COAST GEOTECHNICAL, INC.

W.O. 599020-02

Subject: Response to Report Comments for Proposed Tilt-Up Commercial Building at 11298 Jersey Boulevard, Rancho Cucamonga, California

At your request, COAST GEOTECHNICAL, Inc. has prepared this report providing response to comments addressing sections of the referenced report. The comments are repeated below followed by our response.

Figure 7 – Dam Inundation Zones

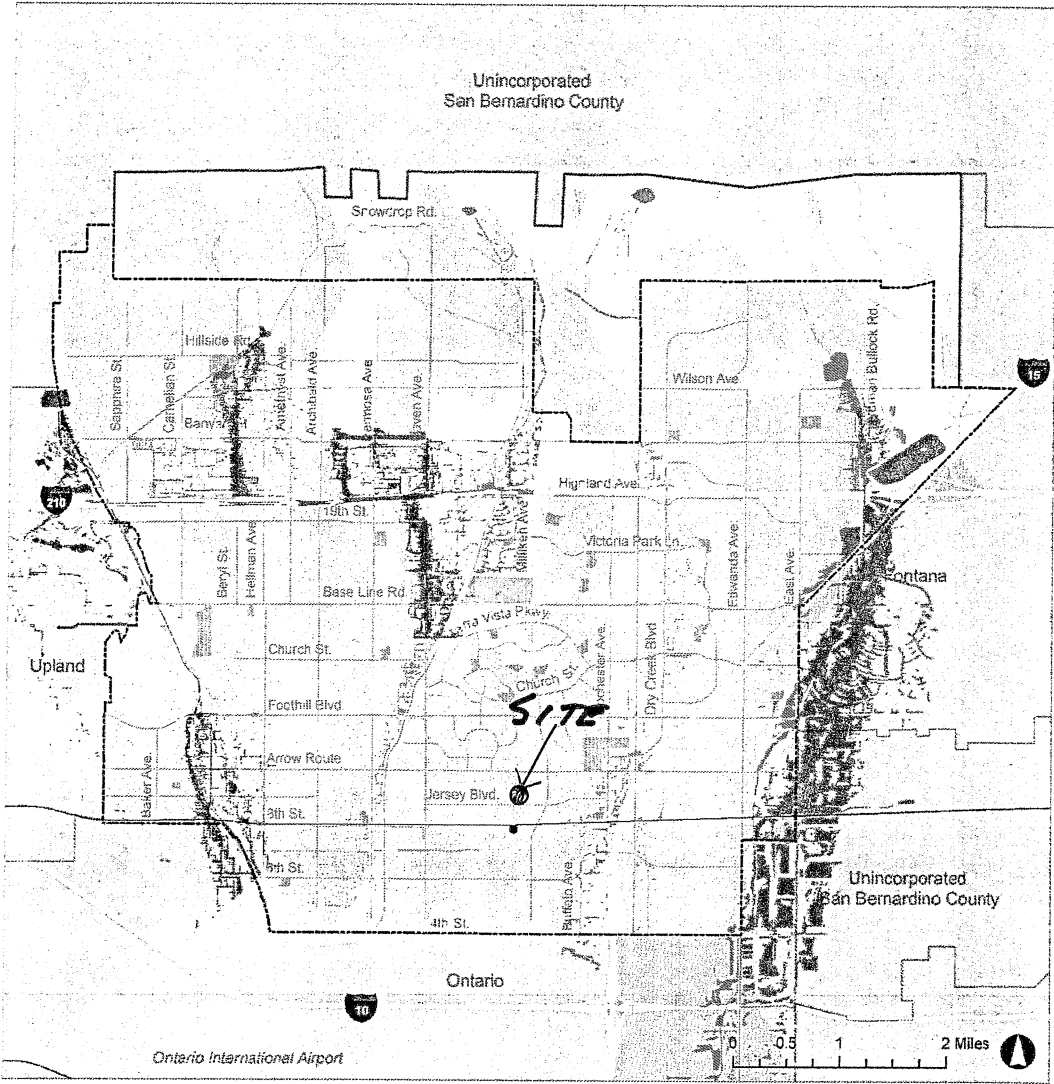
Geo Tech Report, Page 5, line 219: Earthquake-Induced Flooding: The City of Rancho Cucamonga General Plan Update, Natural Hazards Existing Conditions Report (May 2020) identifies seven reservoirs within or adjacent to the City with a combined inundation area of more than 4,000 acres. At a minimum, this document should acknowledge the existence of these reservoirs or catch-basins and sufficiently evaluate the potential for site flooding following a seismic event.

Attached is Figure 7 from the "Natural Hazards Existing Conditions Report, City of Rancho Cucamonga, May 2020" showing areas of inundation from dam structures. The project site is located on this figure and is not within an area of inundation.
